**REGULAR MEETING OF THE
CITY OF ALVARADO PLANNING AND ZONING COMMISSION
104 W. COLLEGE AVE.
JUNE 13, 2024
6:30 PM
AGENDA**

Consideration and action on the application of Chris Wall with JBI Partners, Inc. on behalf of GRBK Edgewood LLC & Century Land Holdings of Texas, LLC for approval of the Lone Oak Addition Phase 1 final plat on 70.219 acres known as tracts and portions of tracts out of the James B. Conger Survey, A-150, and the George S. McIntosh Survey, A-625, approximately addressed at 825 and 1029 CR 607.

JBI has reviewed the comment letter received from the City of Alvarado on the final plat comments and have addressed the comments as follows:

Re: **LONE OAK PHASE 1 CIVIL ENGINEERING PLANS**

PAVING PLAN & PROFILE		PROJECT NO.
CHERRY LANE		BBC010
LONE OAK, PHASE 1		SHEET NO.
City of Alvarado, Johnson County, Texas		1.21

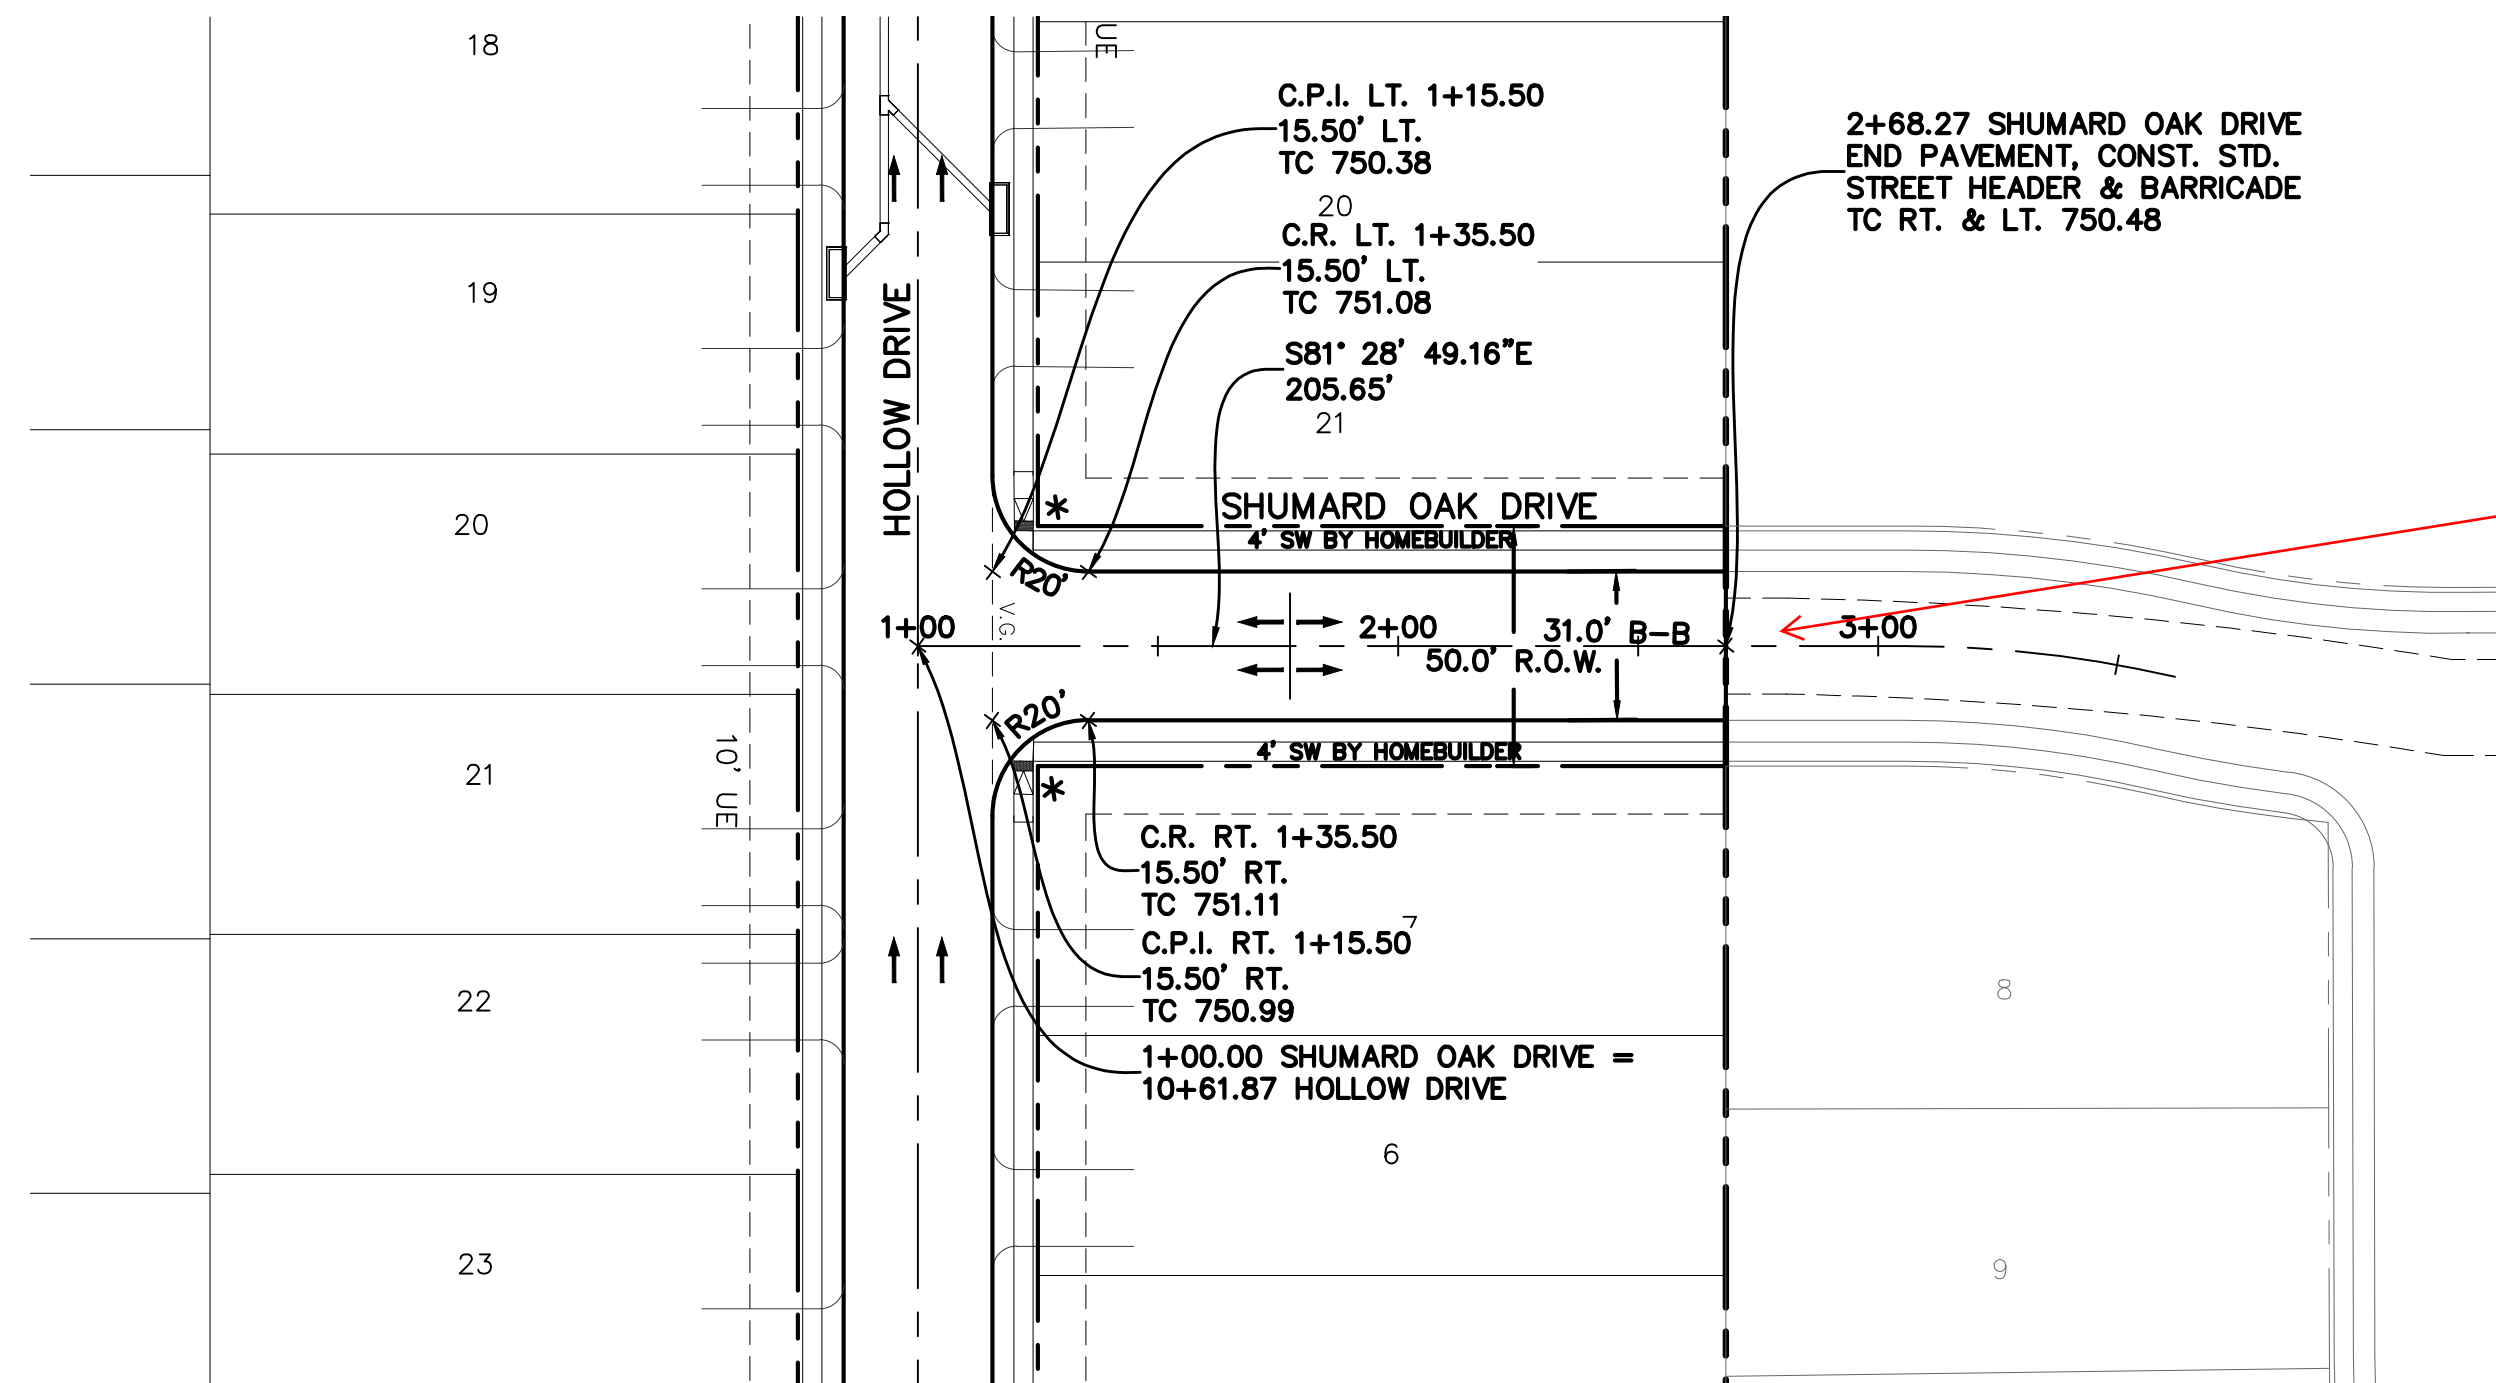
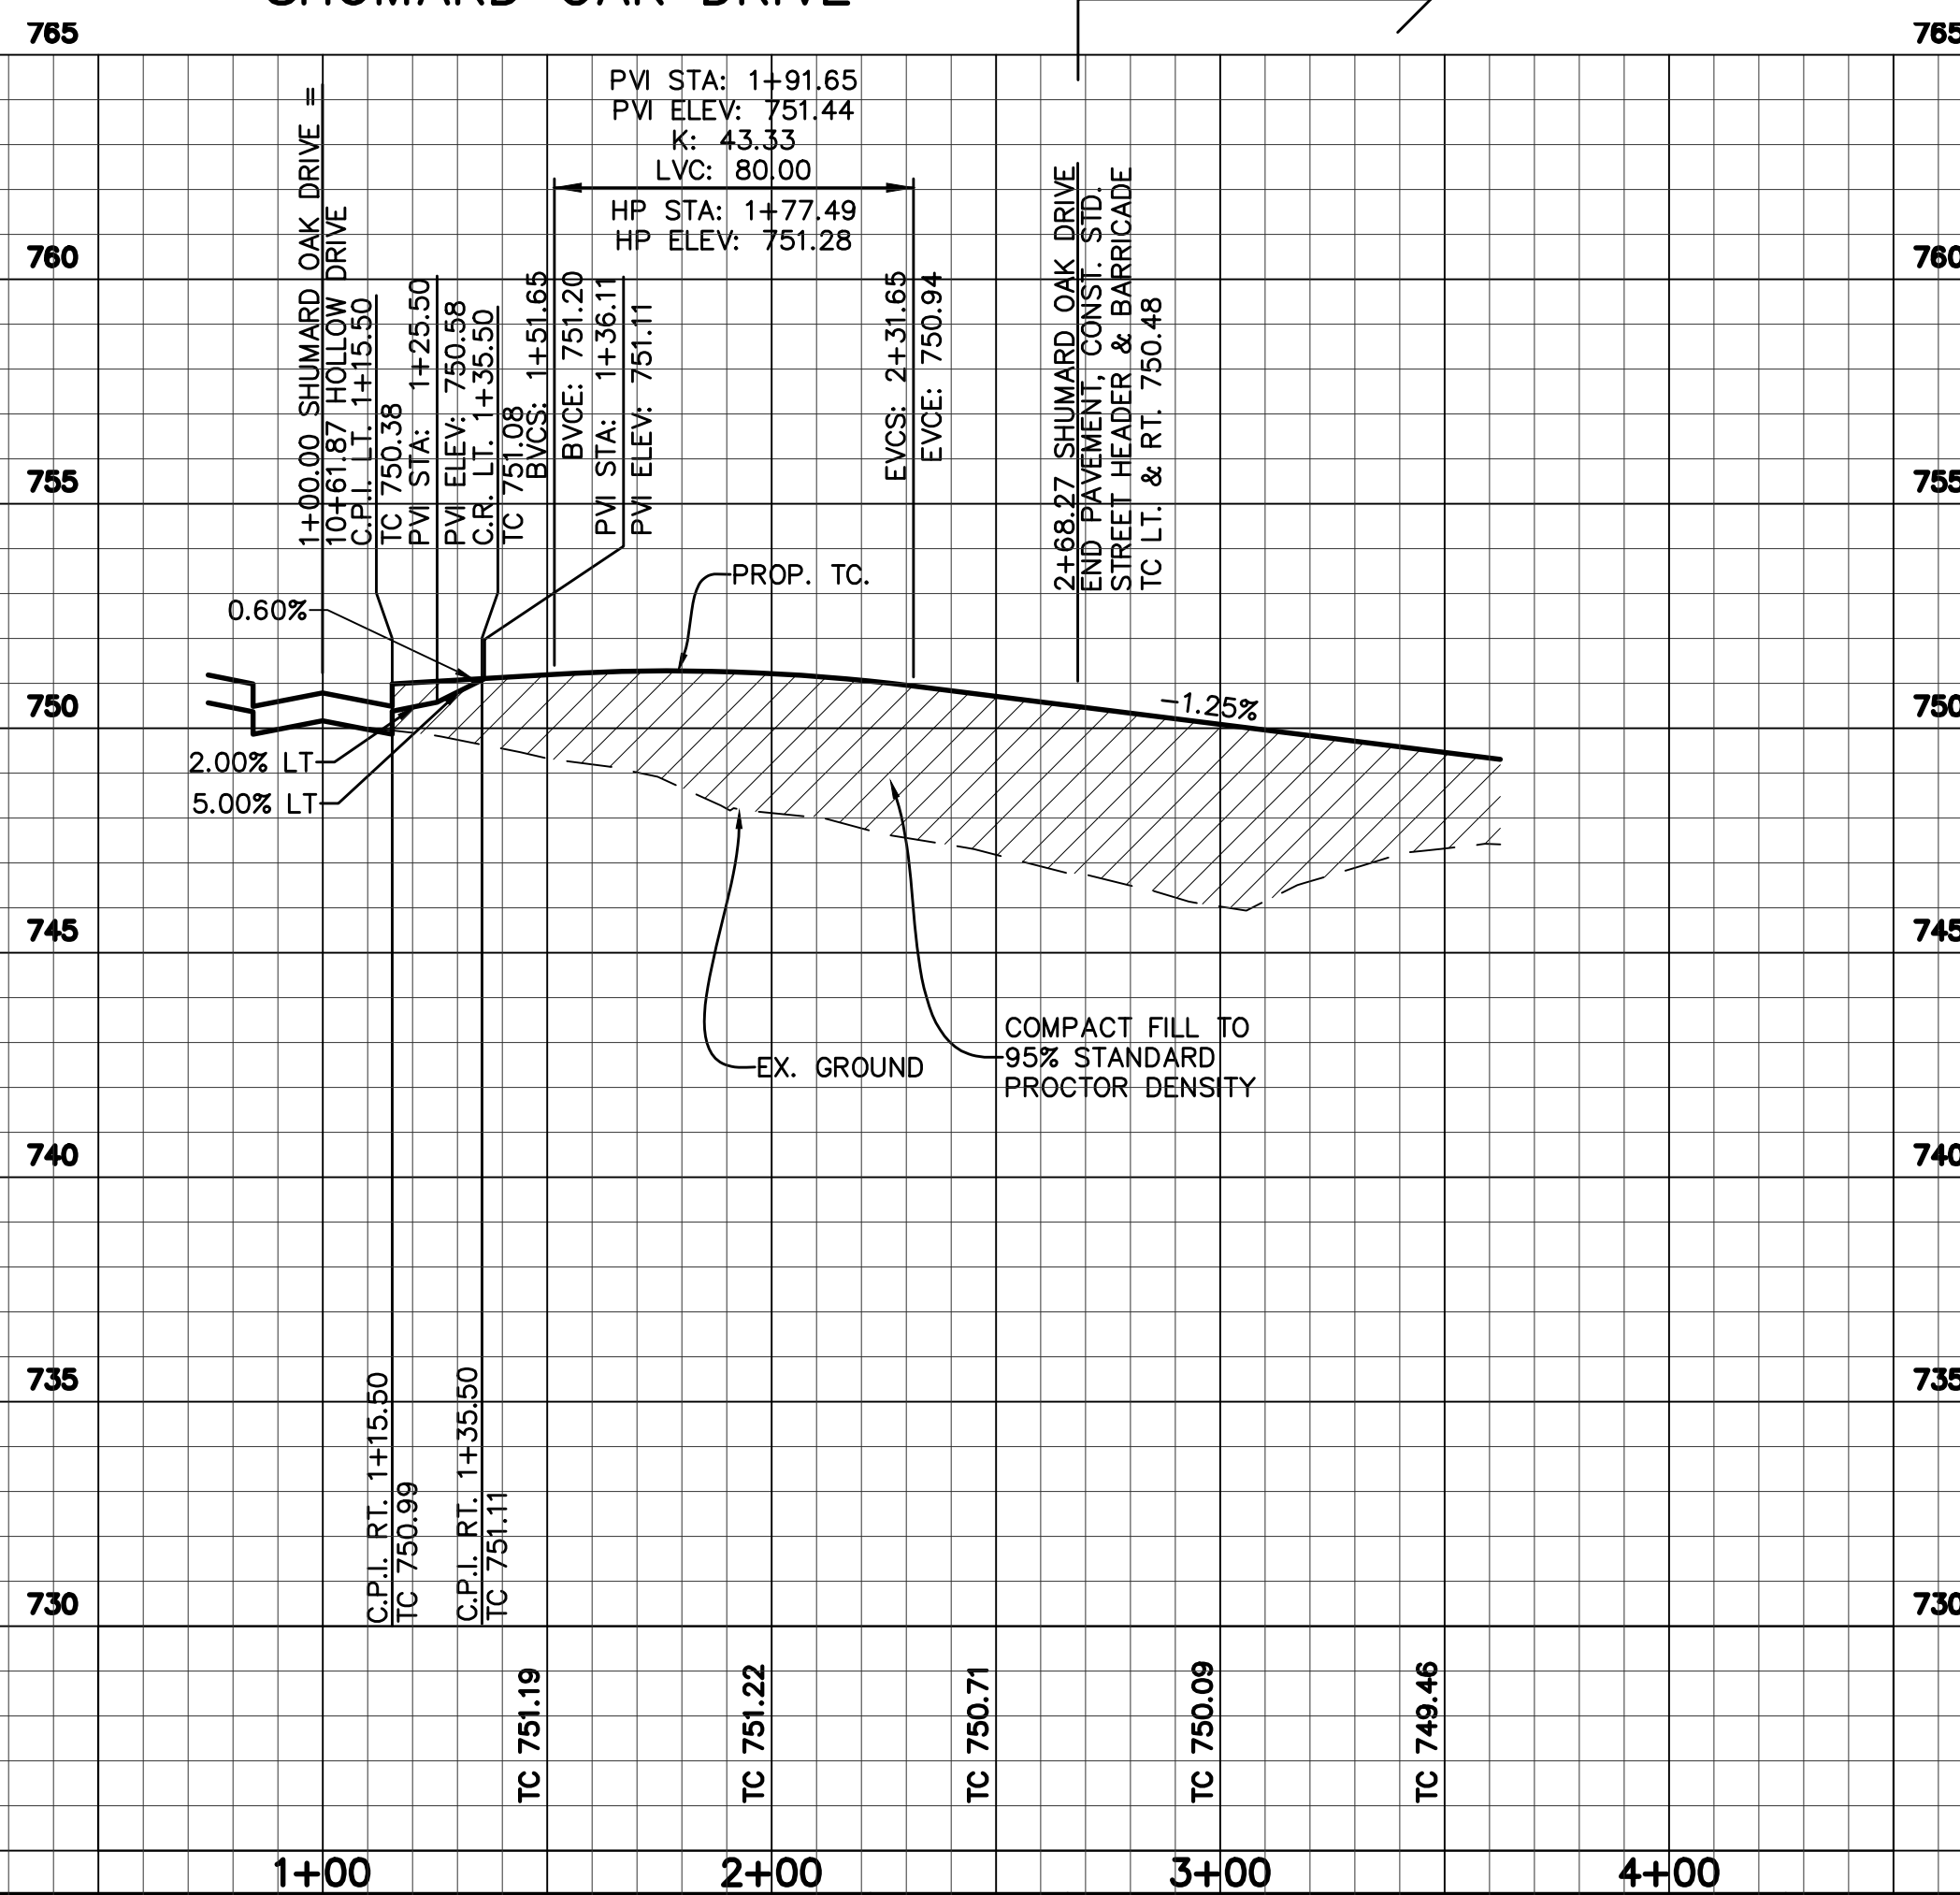
- Create temp channel to convey this to the pond, otherwise one will erode.

SHEET NO. 2.01

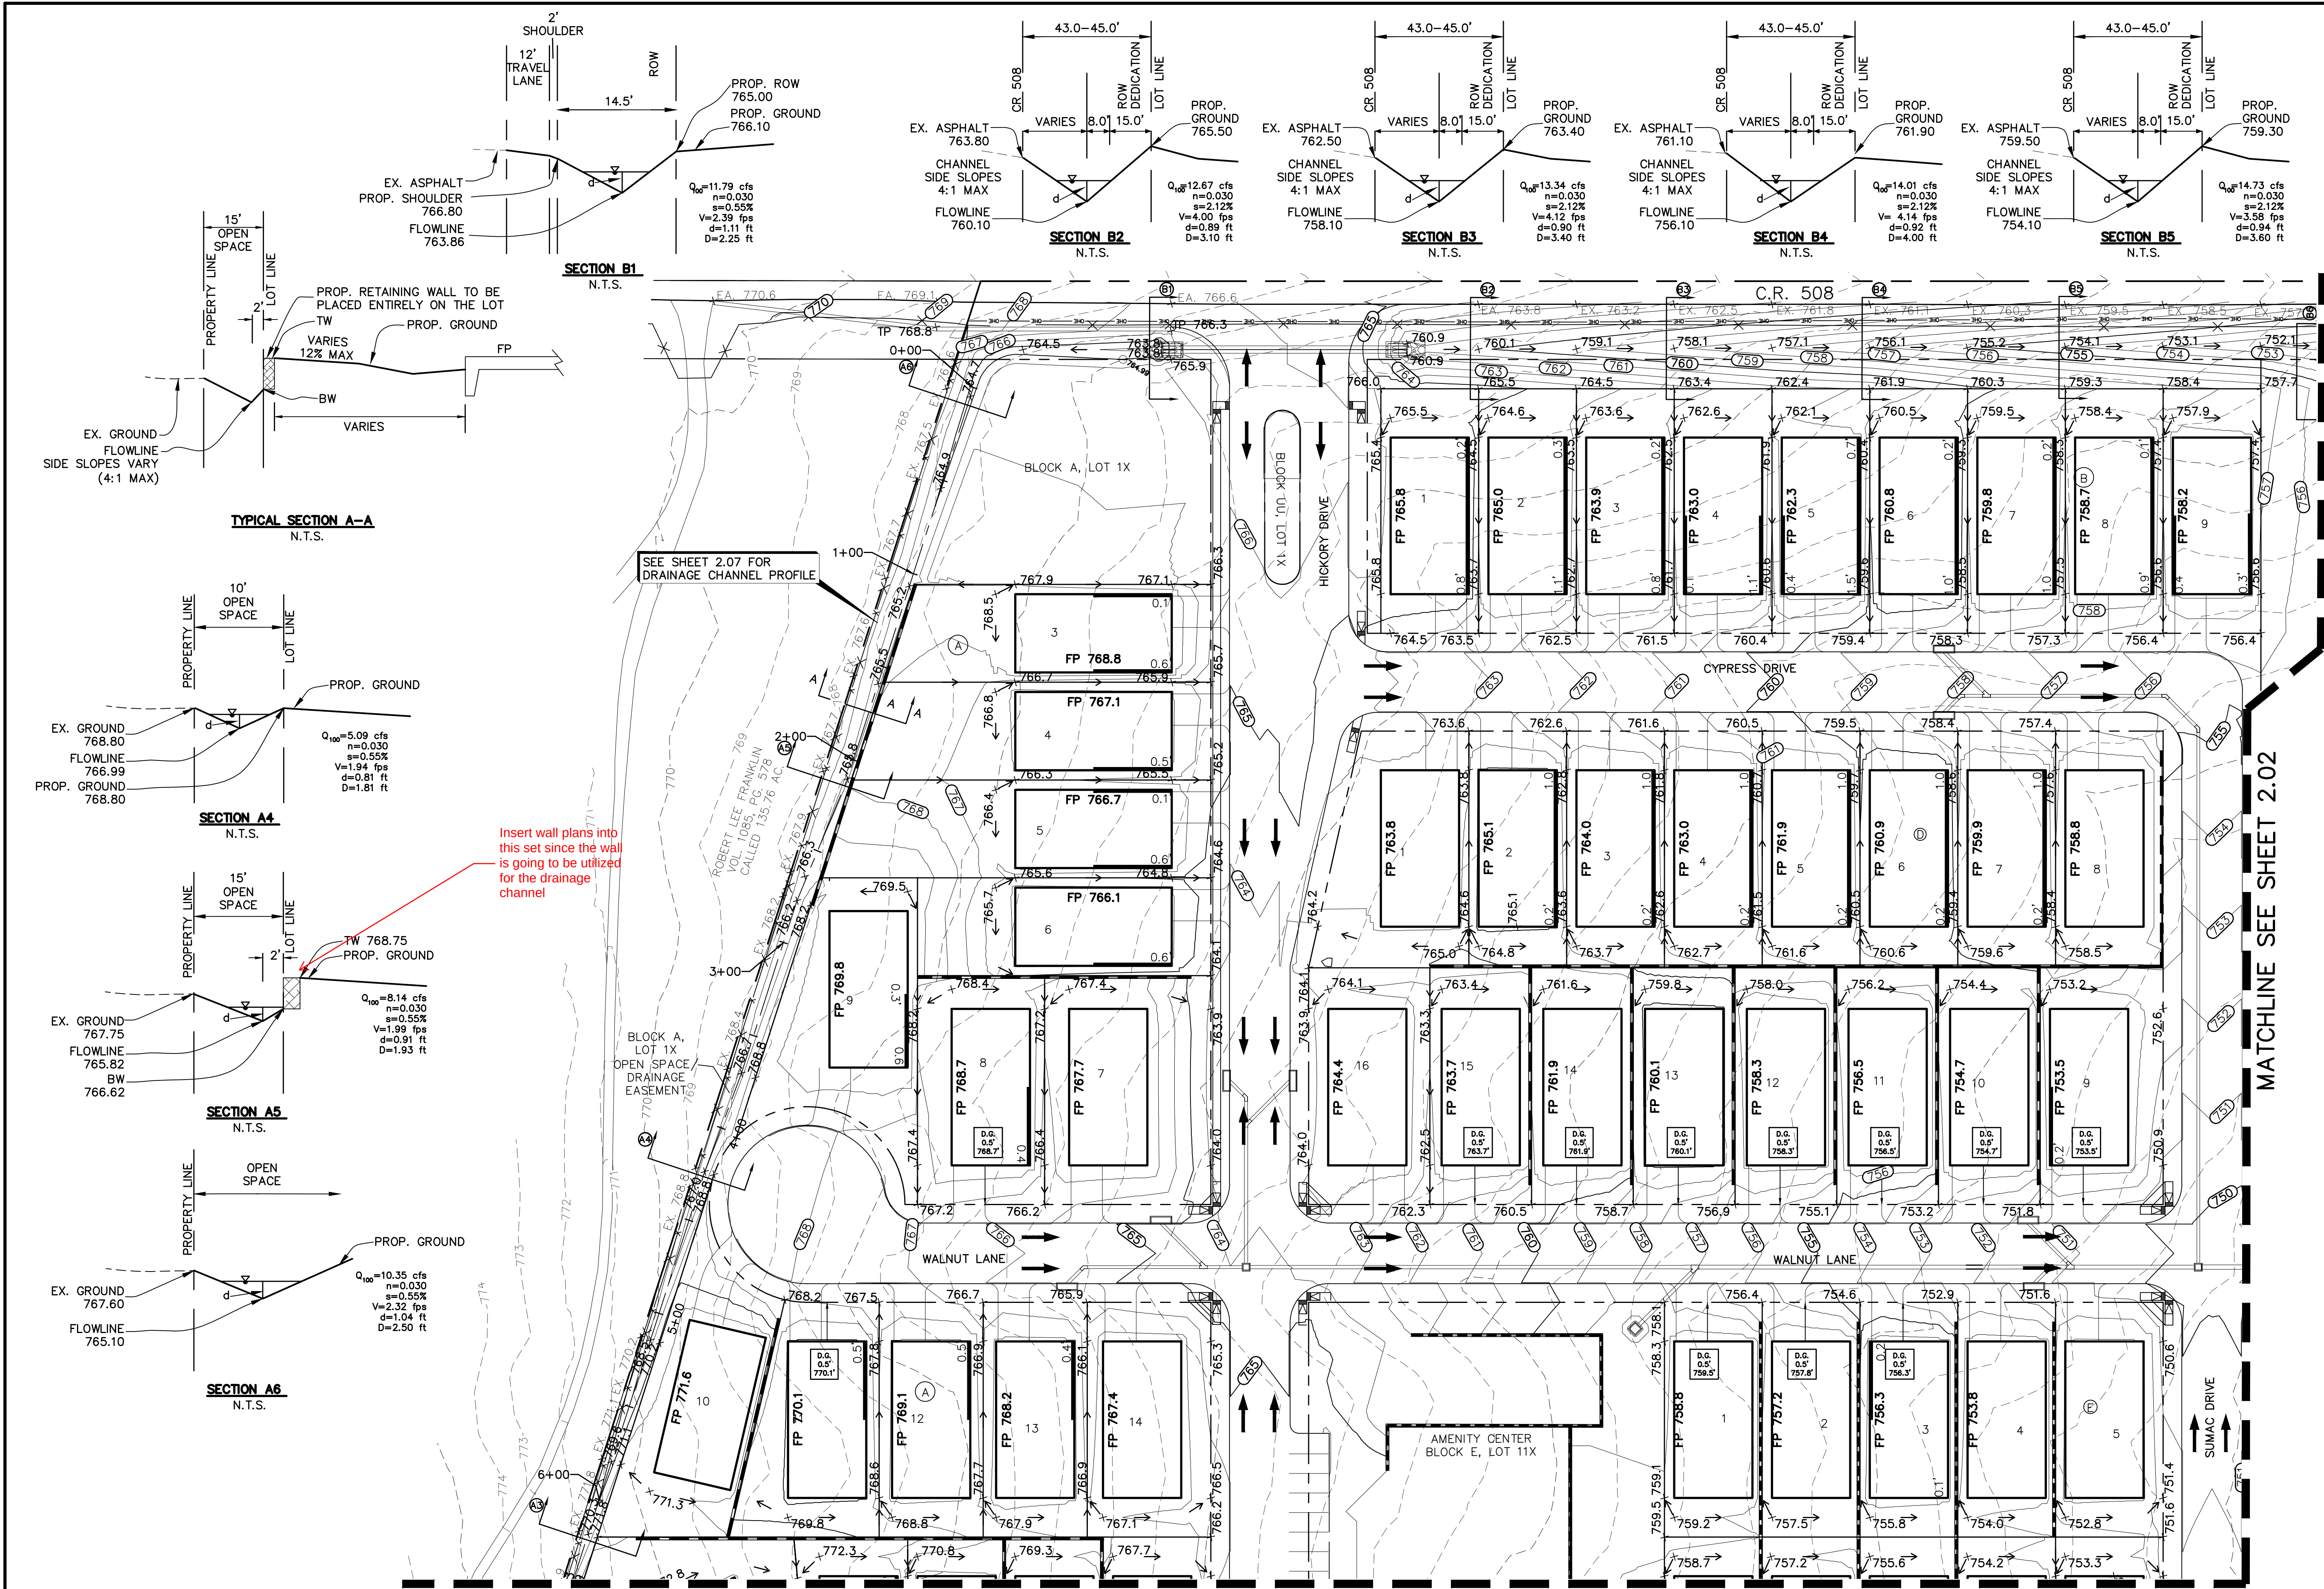
- If 1-ft freeboard cannot be achieved, the development will need to request a variance by the City. At the City’s discretion if the variance is granted.
 - All channels have been modified to meet the 1-ft freeboard. No variance is needed.
- Insert wall plans into this set since the wall is going to be utilized for the drainage channel.
 - The retaining wall plans will be provided at time of permit request. The retaining wall plans will be added to the record drawings at the end of the project.
